COUNCIL ACTION FORM

REQUEST: MAJOR SITE DEVELOPMENT PLAN FOR 2135 COTTONWOOD ROAD

Attachment B: Major Site Development Plan (Landscaping)

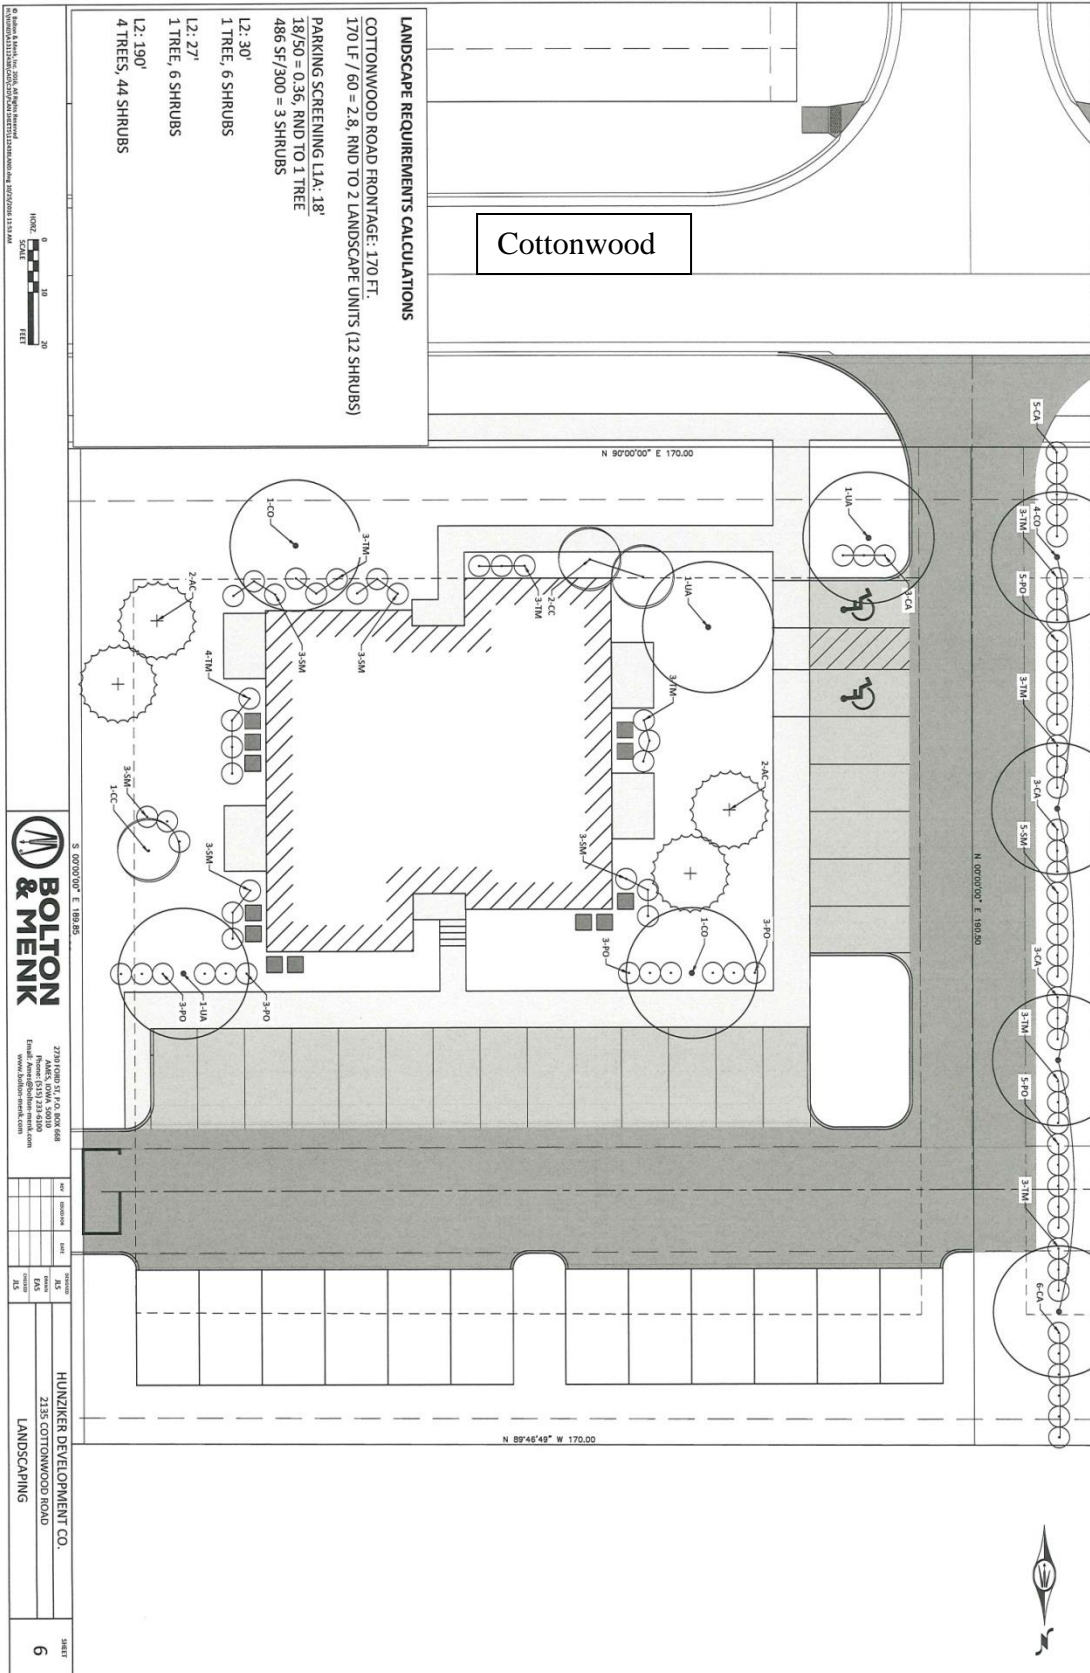
Landscaping is provided to meet front yard apartment foundation and parking lots screening requirements. The developer has proposed parking lot landscaping as a combination of L1 and L2 parking lots screening elements. No landscaping has been proposed or required along the north property line behind the proposed garages due to existing landscaping along the Wessex development. There is potential for an open area on the east side of the building to blend into open area of the apartment proposed to the on Lot 4 to create a relatively flat space for informal use by residents.

Landscaping requirements are driven by parking lot design and front yard plantings for apartment buildings (Page 18 of the report is the landscape plan). The proposed project's landscaping is most affected by the front yard foundation plantings due to the length of street frontage and the location of the parking. Due to the placement of garages along the north boundary line, screening is not required. The 10-foot area behind the garages is planned to be planted as turf. Screening would be needed if the garages did not abut an existing landscaped yard of the abutting Wessex apartments to meet the intent of the FS standards.

Front yard foundation plantings requirements include a combination of shrubs, understory and overstory trees. The developer has included additional cluster landscaping along the sides of building to add interest and some screening for the residents from the parking lot. Staff has an interest that an open relatively flat area be created between the apartment buildings of Lot 4 and Lot 3 to allow for informal open space. The area to the east of the building is planned as turf and can be graded with minimal slope to meet this interest of having available space for recreational use. There will be approximately 70 feet between buildings and 6000 square feet of informal open space between the buildings on Lots 3 and 4.

The Landscape Plan shows screening for mechanical units along the east and west sides of the building that meet site plan standards, provided the shrubs used for screening are a minimum of six inches higher than the mechanical units, at the time of planting. A condition is included in the report as a reminder of the need to comply with screening at the time of planting compared to growing into a screen over time.

No interior parking lot landscaping is required due to the size of the parking lot with one drive aisle. Perimeter parking lot landscaping is required along the portions of the driveways, parking spaces, and drive aisles to meet perimeter parking lot landscaping. All but one area of the site has the required perimeter parking lot landscaping. The side of the parking space that faces the property at 2121 Cottonwood, to the east, requires five shrubs to meet the "L2"(Low Screen) landscaping standards. The developer does not believe landscaping is needed at the terminus of this drive aisle as it abuts another drive aisle. The City Council can approve modification of landscaping screening

requirements if it finds that an alternative design meets the objectives for parking lot screening. Staff finds that the minimal length of area could be planted, but the overall mix of plants has diversity and interest in the design while meeting the essence of screening objectives of the zoning ordinance (See *Attachment B: Major Site Development Plan, Landscaping- pg 18*).

The trash receptacles are screened with 1" by 6" vertical cedar wood alternating slats to a height of six feet. The site plan does not include gates for the enclosure. Gates are necessary to meet screening requirements in Section 29.408(3) of the Municipal Code, which requires that garbage collection areas be screened from all public rights-of-way and from adjacent properties.

- C. The landscape plan shall include revisions necessary to specify plantings appropriate in size equal to the height of the mechanical equipment to ensure the compliance with the zoning ordinance screening requirements.

- D. The landscape plan shall include revisions for six additional shrubs to meet the landscaping requirements for the front yard of apartment buildings in the FS-RM zone.

Attachment C: Building Elevations

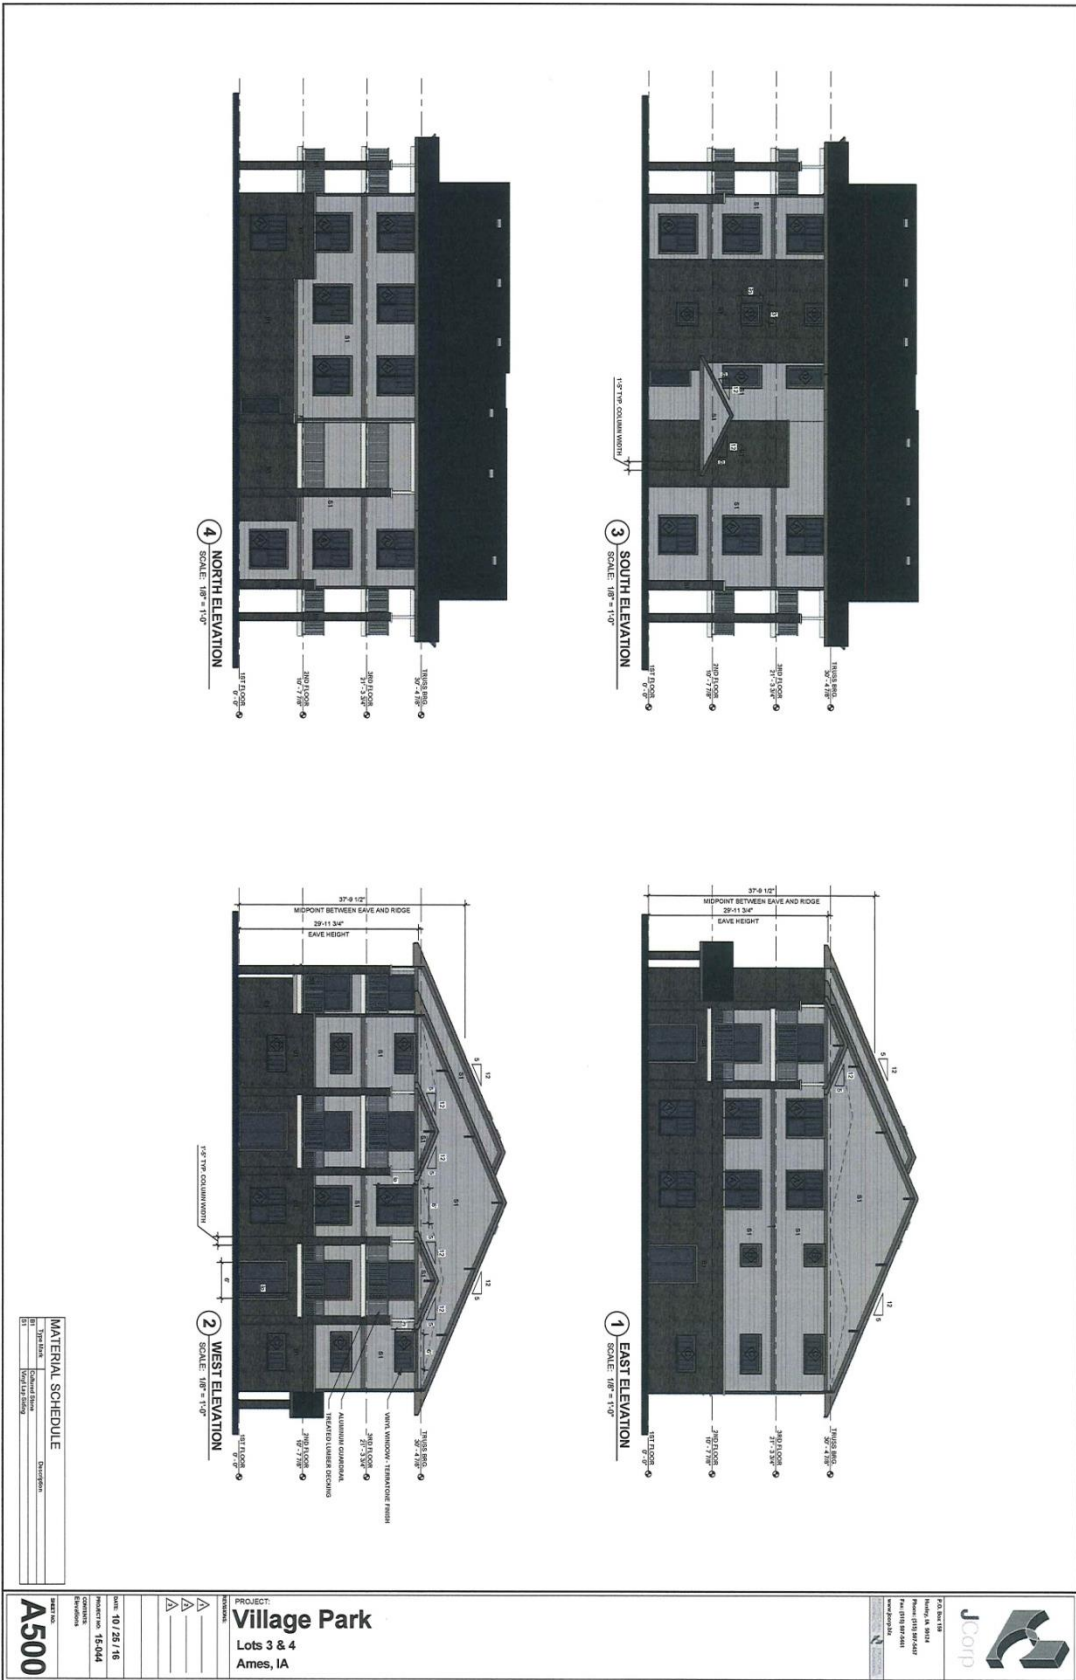
The 12-unit building is consistent with the maximum building size allowed in the FS-RM zoning district. The building is three stories in height. Four stories, or 50 feet, whichever is lower, is the maximum building height permitted for multiple-family dwellings in the FS-RM zone. Ten of the twelve apartment units have access to either a small patio or a balcony. The 2-bedroom units, on the second and third floors of the northeast corner of the building, do not have balconies. The apartment building design incorporates a 5/12 pitched gable roof design, and asphalt shingles.

Two primary exterior materials are proposed for the building. The majority of the first floor is to be surfaced with cultured stone, while the second and third floors, and the gables are primarily vinyl lap siding. Cultured stone will extend to the roof line on approximately one-third of the south façade, and to the top of the first floor level at the primary entrance to the building. The primary (south) building entrance will include a 5/12 gabled roof above the entrance, as will also be a design feature above each of the

decks on the second and third levels of the building. Decks will be constructed of treated lumber with aluminum guardrails, and supported by pillars of cultured stone. The two (6-stall) garage structures will have similar materials and design features with a band of cultured stoned at the bottom of each façade, vinyl lap siding on the remainder, metal overhead garage doors, and a gabled roof with asphalt shingles and a roof pitch of 6/12. The cultured stone is a dark brown color, and the vinyl lap siding is a lighter brown color with two different variations of tan shading. Each façade has some variation in wall plane to add interest and provide some relief in the architecture (*See Attachment C: Building Elevations & Attachment D: Garage Elevations*).
